MC34709, Silicon Errata (N88D)

This errata document applies to the MC34709 data sheet.

Document Number: MC34709ER
Rev. 3.0
11/2012

Figure 1. RTC Workaround Application Circuit

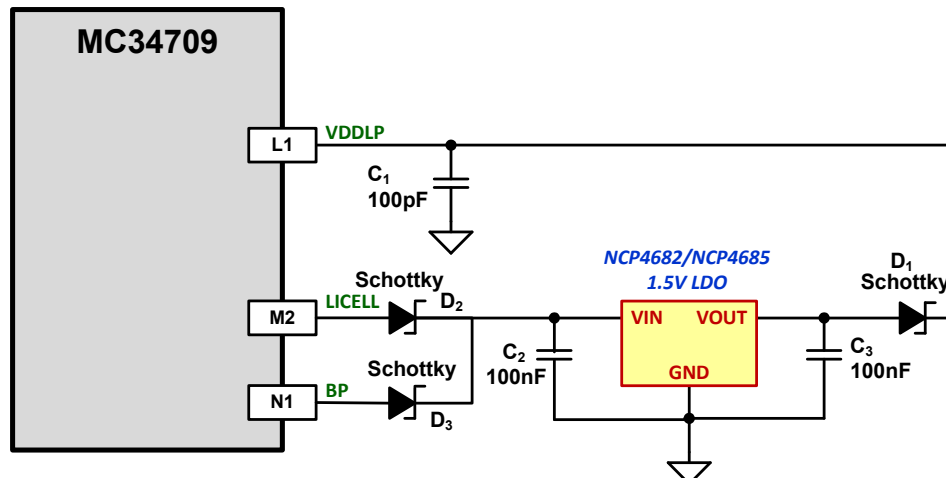
Errata Number	Erratum	System Impact	Description
High Severity Level			
4	Buck Regulator: Regulator output undershoot in APS mode.	Undershoot may cause processor to shutdown.	In APS mode the regulator output may undershoot for approximately 10 μs under transient loads of 1/2 of max rated current. Output voltage may drop as much as 160mV. Workaround: SW1-5 must be operated in PFM mode for loads lower than 100 mA and in PWM mode for loads greater than 100mA in order to meet the transient load response specification. Fix Plan/Status: No fix scheduled.
5	RTC: VSRTC drops out with slowly decaying battery and a valid coin cell.	In applications with a Li-Ion battery, the RTC can be lost when the battery voltage drops to ~2.2 V. In applications where VBATT is driven by an external source, the RTC can be lost as the voltage transitions below the 2.2 V range during power down.	There is an issue with the 'Best of Supply' switch, which powers VDDL P. During the change over from the primary power source to the coin cell, the VDDL P can dip to a voltage below the minimum voltage required to power the RTC. - The VSRTC supply is derived from VDDL P, and therefore affects the RTC of the application processor, as well as the on-board RTC - The 32 kHz clock to the processor's SRTC also drops out. Workaround: Figure 1 is the application circuit recommended for all applications where the RTC is used with a back-up coin cell attached to the MC34709. The LDO output is set to 1.5 V with a Schottky diode in series which keeps the voltage supplied to VDDL P below the VCOREDIG (1.5 V). - Add a low quiescent current 1.5 V LDO, supplied by the coin cell (LICELL pin). Recommended LDO: NCP4682/4685⁽¹⁾ or equivalent with a 1uA typical IQ. - Add a low voltage Schottky diode (D1) to block the output capacitance (C3) of LDO. - Add a low voltage/low leakage Schottky diode (D2) from LICELL to VIN of the LDO. - Add a low voltage/low leakage Schottky diode (D3) from BP to VIN of the LDO. Fix Plan/Status: No fix scheduled
